Private Fuel Storage, L.L.C.

**REQUEST FOR ADDITIONAL INFORMATION
ON AIRCRAFT HAZARDS – PARTIAL RESPONSE
DOCKET NO. 72-22 / TAC NO. L22462
PRIVATE FUEL STORAGE FACILITY
PRIVATE FUEL STORAGE L.L.C.**

**RESPONSE TO MARCH 9, 2001 NRC REQUEST FOR ADDITIONAL INFORMATION
REGARDING AIRCRAFT AND CRUISE MISSILE HAZARDS AT THE
PRIVATE FUEL STORAGE FACILITY**

Ceiling @ 9,000'

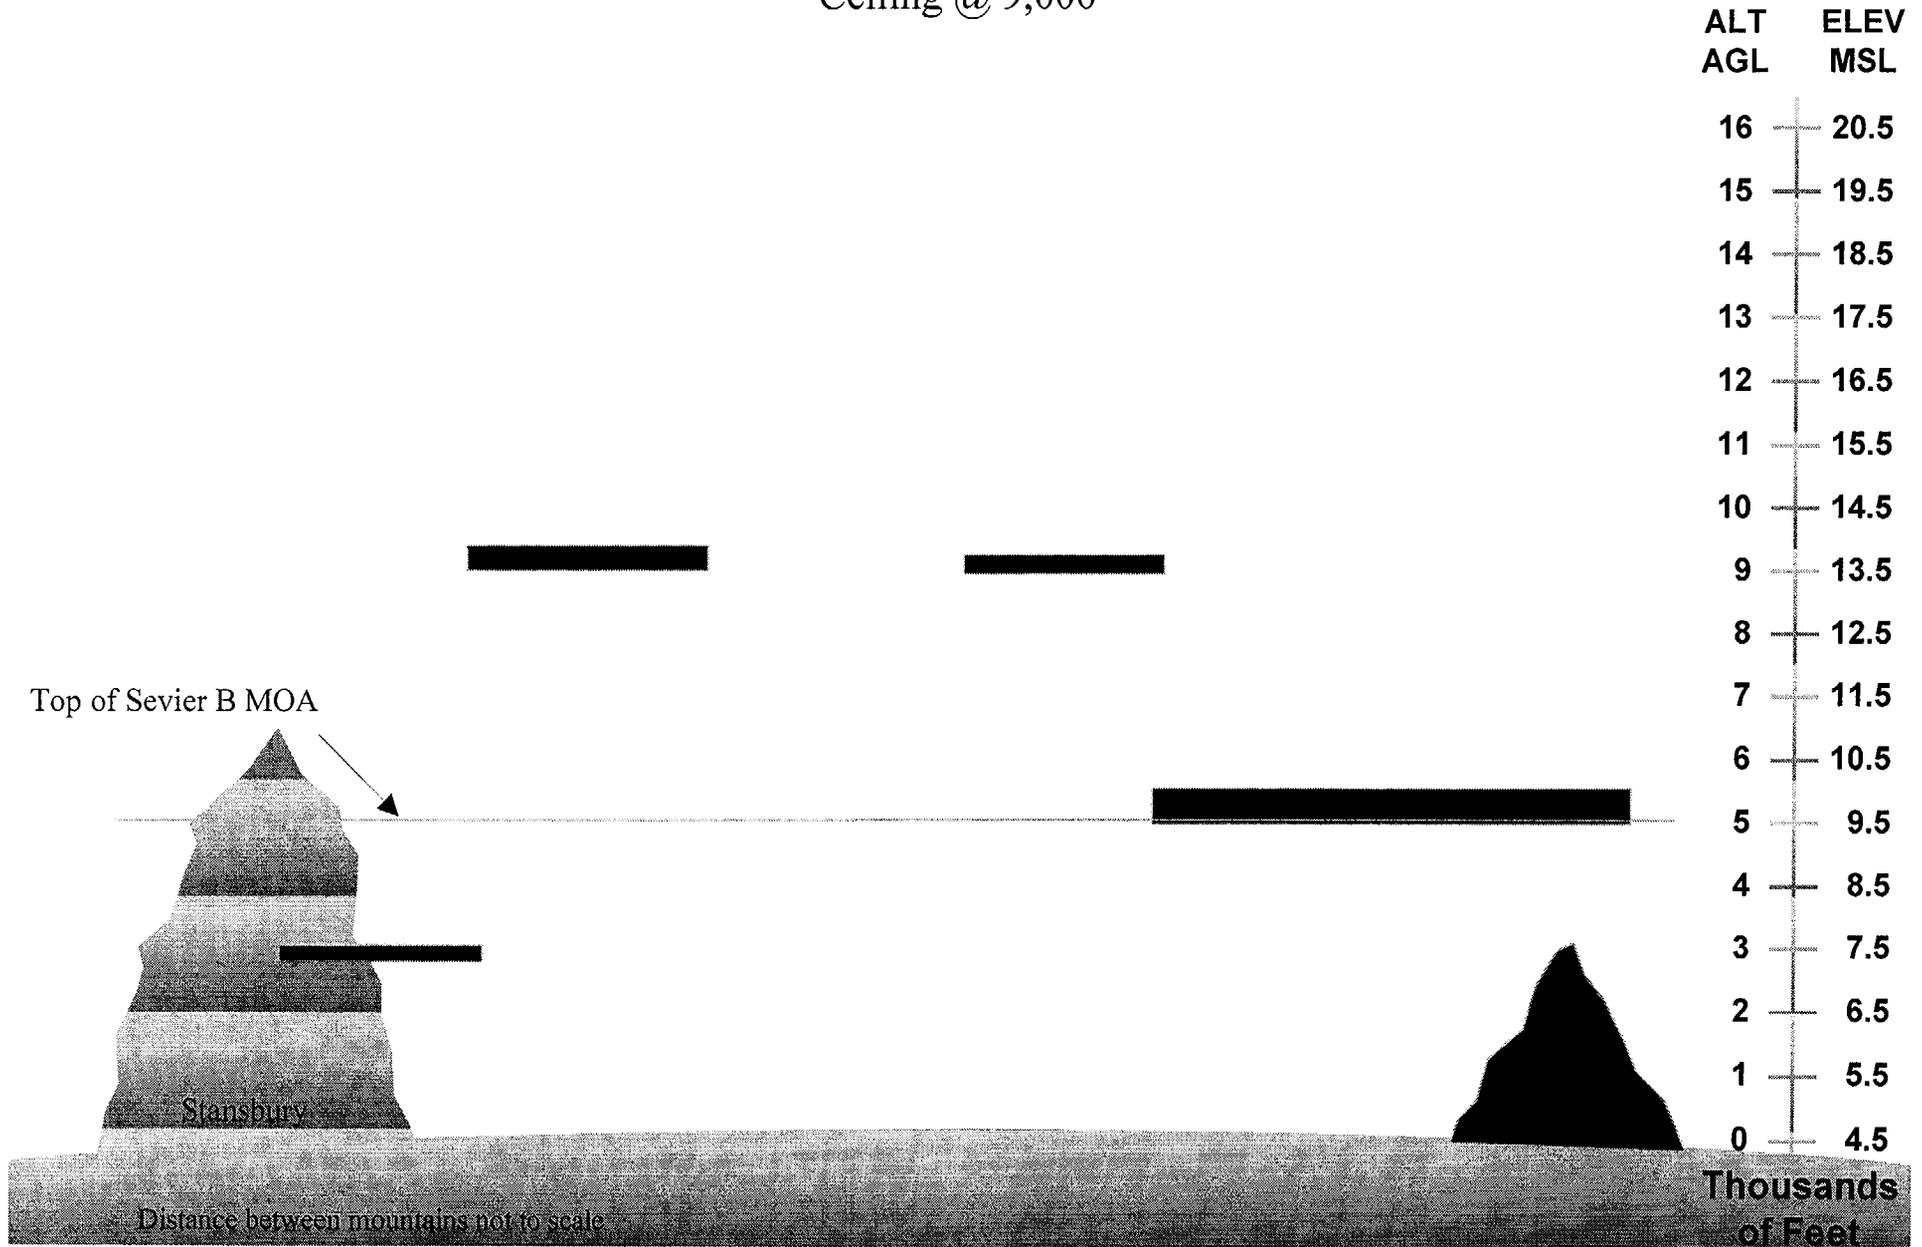
Figures 9-9 through 9-12 show examples of the ceiling and visibility which correspond to the Sevier B MOA. As can be seen from the AWS data, this is the prevailing ceiling and visibility condition 91.5% of the time. In essence, pilots should be able to maintain VFR in the Sevier B MOA the vast majority of the time.
